Downstream Authority of the Quapaw Tribe of Oklahoma Regular Meeting  
September 14, 2011

JCJ Review

## Downstream Casino Resort Expansion

September 14, 2011

**C-STORE FLOOR PLAN**

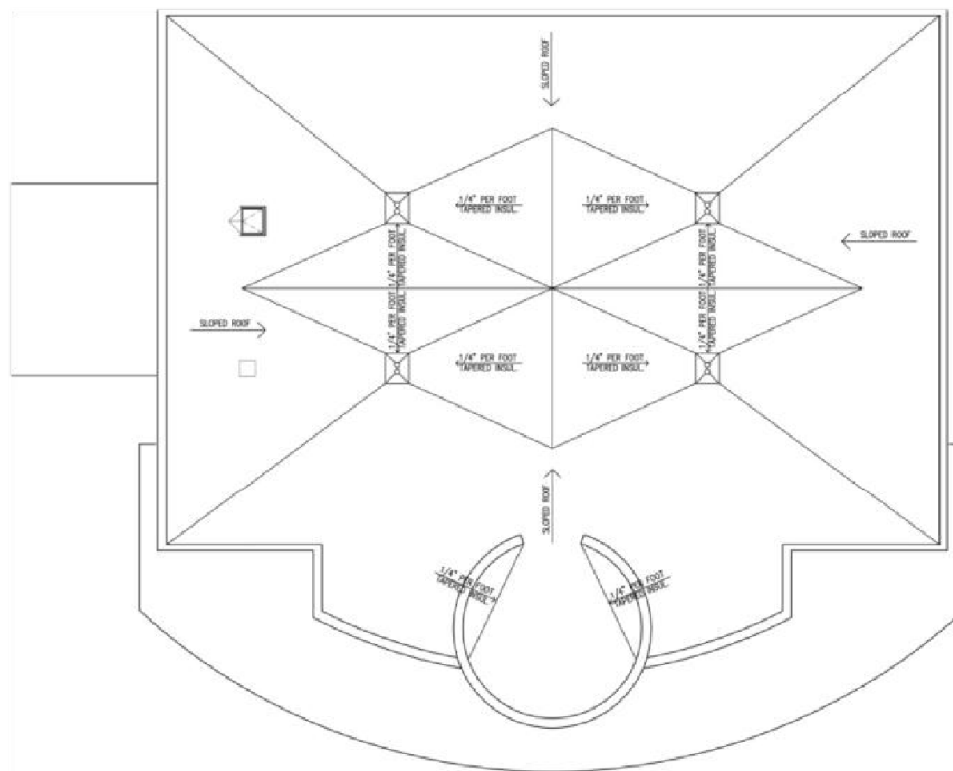
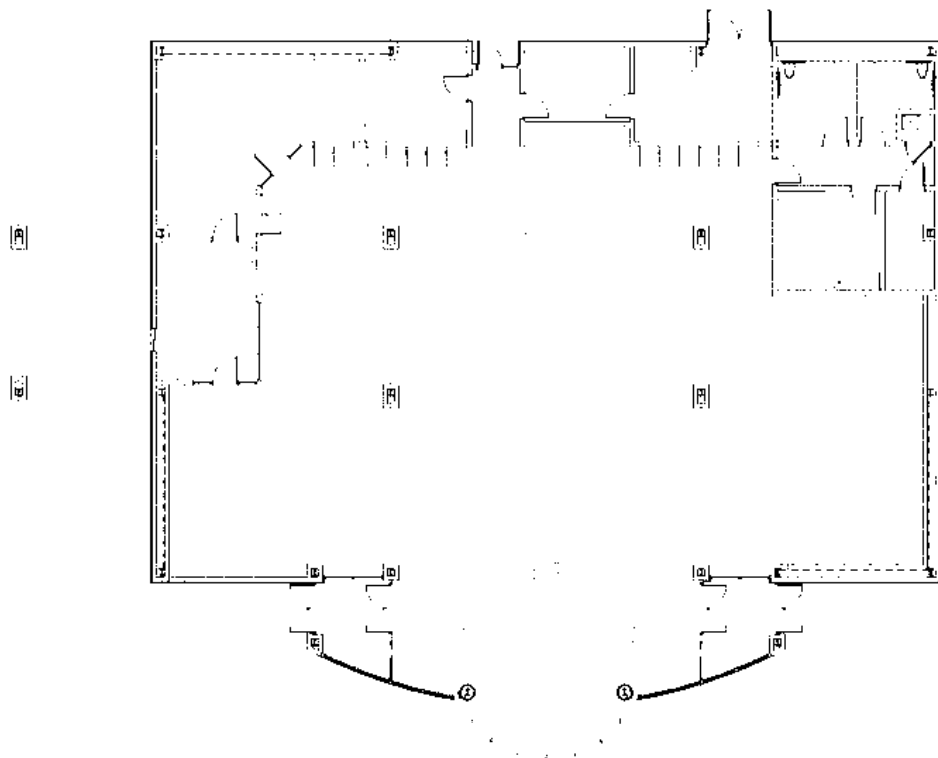
- Propane exchange & refill
  - o Tank @ rear of property (west side)
- Additional truck parking @ CStore (21 on RV Lot/ 7 on CStore lot)
- 8,000 square feet
- Back up generator
- EVS will be responsible for deep clean of the store couple times a week, staff will handle day to day cleaning
- Manager office/Cash room
- 2 options presented for building design (RV Laundry/Shower)
  - o Consensus of the DDA for option A w/ seal moved center or on a standalone sign
- Concrete floor – similar to pavilion floor

## HOTEL EXPANSION - LOWER LEVEL FLOOR PLAN

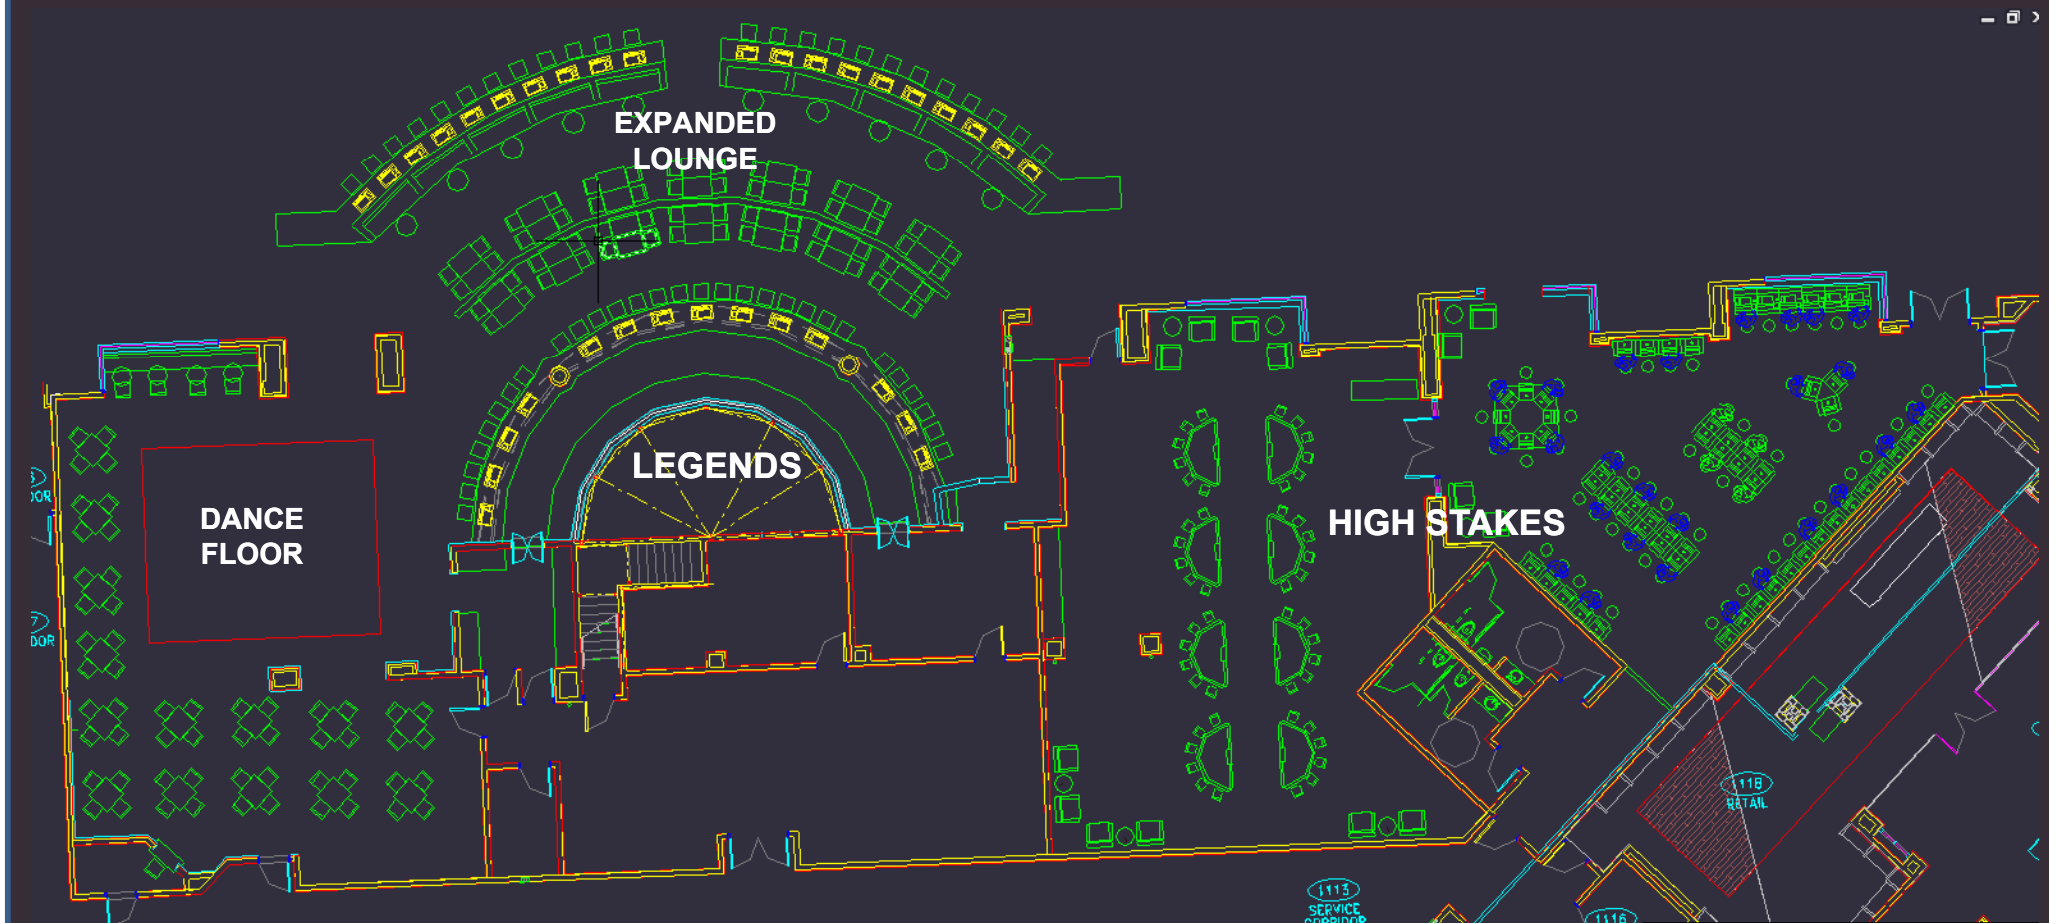
- Review previous discussion
- Look at power point w/ discussed changes (attached)
- BOH traffic flow
  - o How to get between the two towers
- Lower Level floor plan
  - o Children's Lounge
    - Staffed – arts& crafts, video games, movie corner
  - o Staff Area
    - Bathroom
    - Break area
  - o Laundry
    - 2 each commercial grade washer/dryer
- Guest Service/Registration
  - o Historical tribal info across from registration desk
  - o Sales office
